Notice of Intent

Sundry ID: 2760646

Procedure Description: Variance Request Matador requests a variance to have the option of running a multi-bowl wellhead assembly for setting the intermediate 1, 2 and Production Strings . The BOP s will not be tested again unless any flanges are separated. Matador requests a variance to drill this well using a co-flex line between the BOP and choke manifold. Certification for proposed co-flex hose is attached. The hose is not required by the manufacturer to be anchored. If the specific hose is not available, then one of equal or higher rating will be used. Matador requests a variance to have the option of batch drilling this well with other wells on the same pad. In the event that this well is batch drilled, the wellbore will be secured with a blind flange of like pressure. When the rig returns to this well and BOPs are installed, the operator will perform a full BOP test Matador requests a variance for the use of a diverter along with a 2000-psi annular to be installed after running 20" casing. Matador requests the option to cut off 20" SOW wellhead and run 13-3/8" SOW multi-bowl wellhead system once 1st intermediate string is run and cemented

21-1/4" Diverter Stack

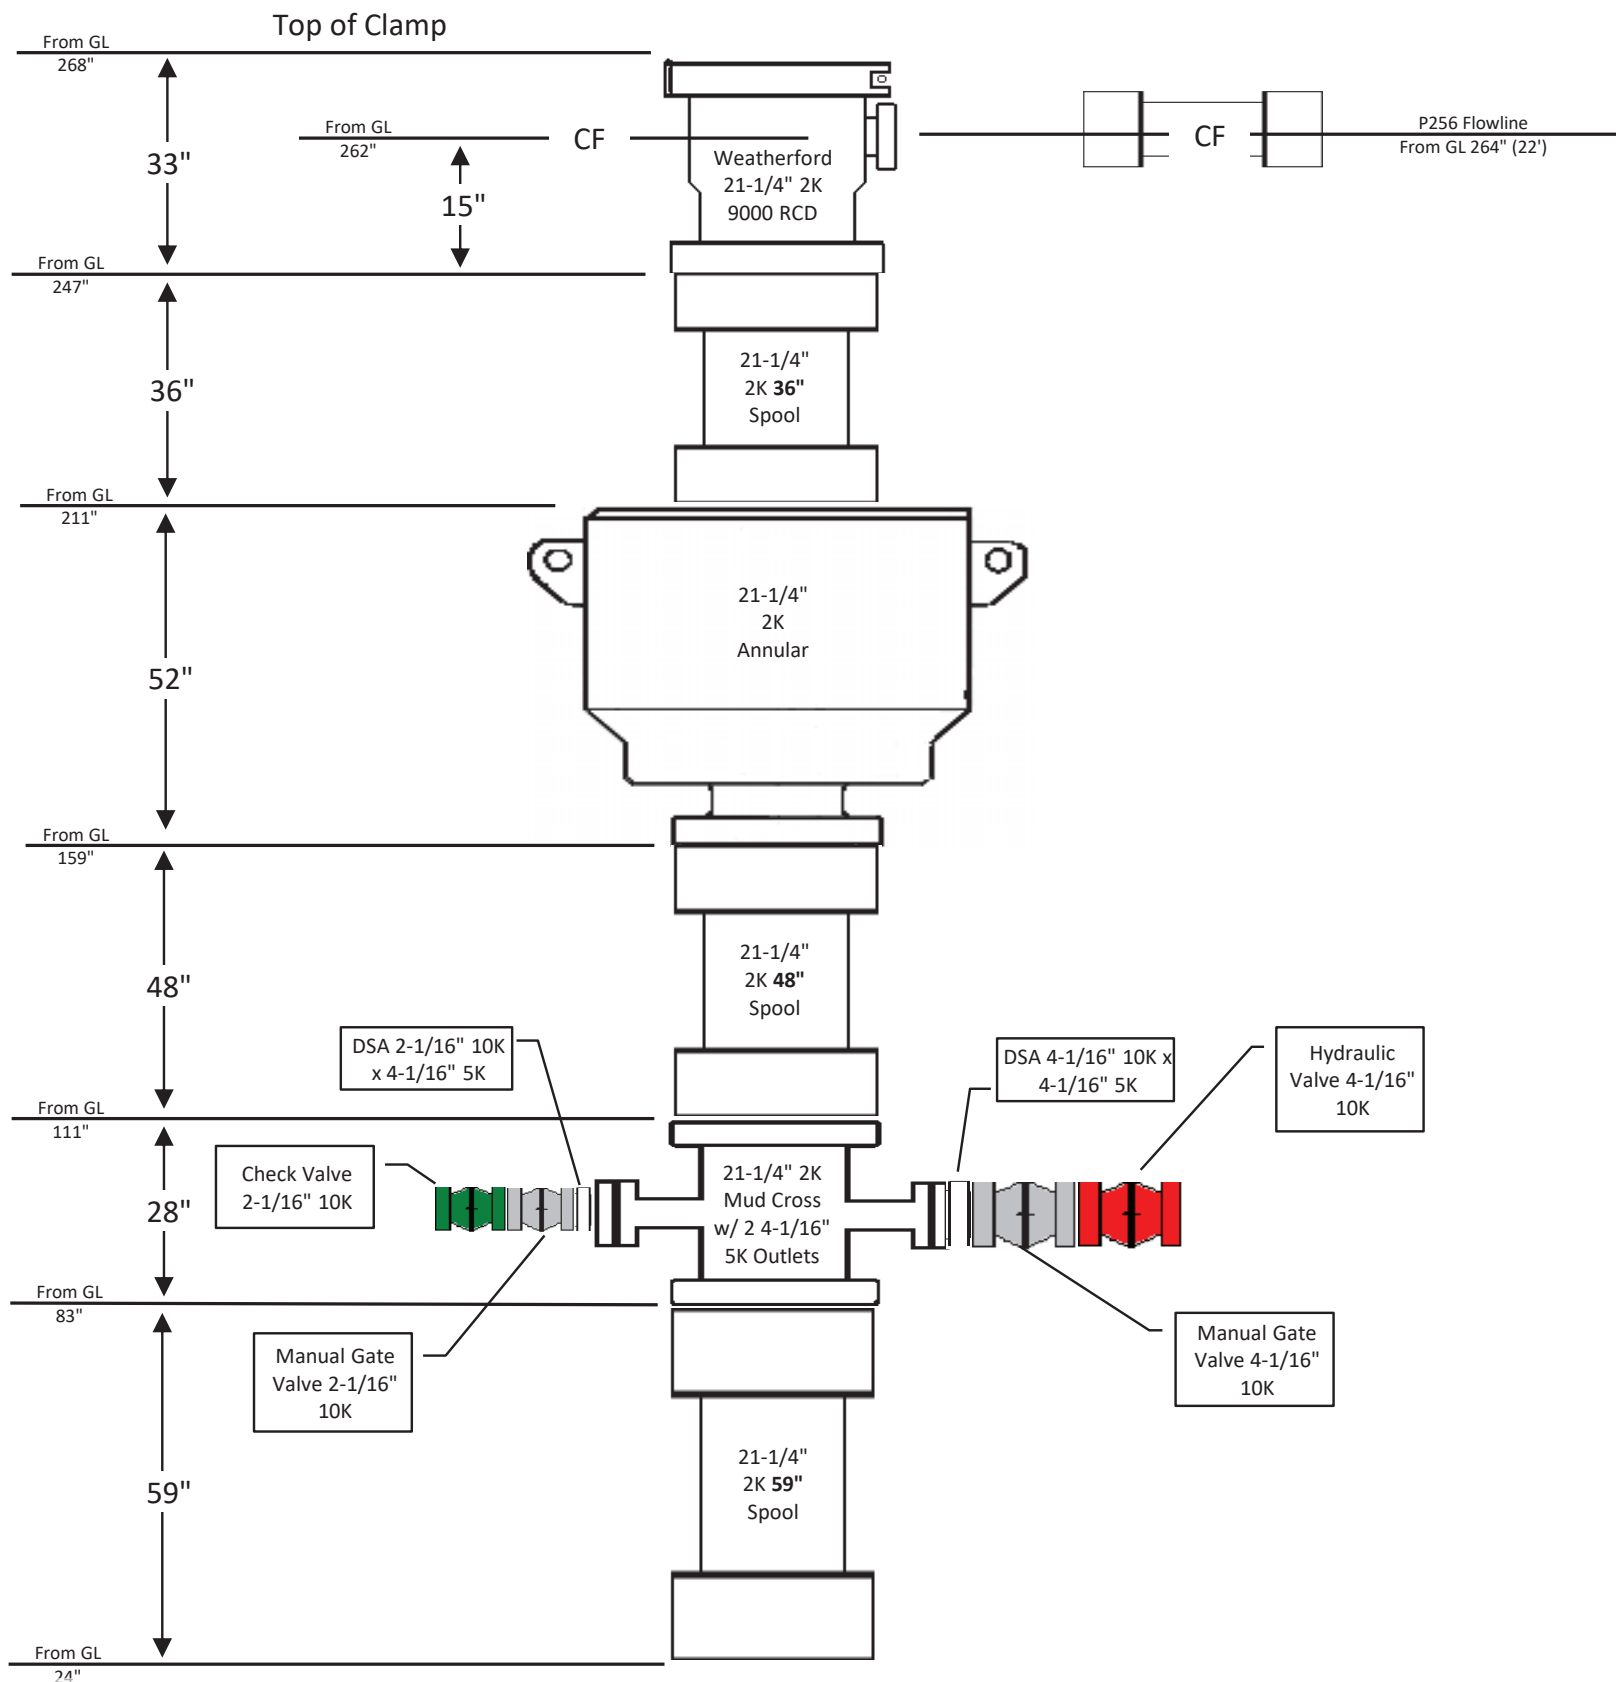
Matador requests a variance for the use of a diverter along with a 2000-psi annular to be installed after running 20" casing.

As per our conversation, we request approval to run a diverter with a 2,000 (2M) psi annular, to drill the 1st Intermediate casing.

“Matador requests a variance for the use of a diverter along with a 2000-psi annular to be installed after running 20” casing, which will be tested to 1000 psi.”

You are approved, please follow up with a formal sundry within 5 business days with the email approval attached. Please have this approval on the rig site.

2900' x 10.2 ppg x 0.052 - .022 x 2900' = 900 psi MASP (Minimum required BOPE is a 2M annular tested to 50% Working Pressure)

Minimum working pressure of the BOP/BOPE required for drilling below the surface casing shall be 2000 (2M) psi. A Diverter system along with a **2000 (2M) psi annular preventer** is approved to be used when drilling the 17-1/2 inch hole. Before drilling out the surface casing shoe, diverter system and annular preventer shall be tested in accordance with **title 43 CFR 3172** and **API Standard 53**.
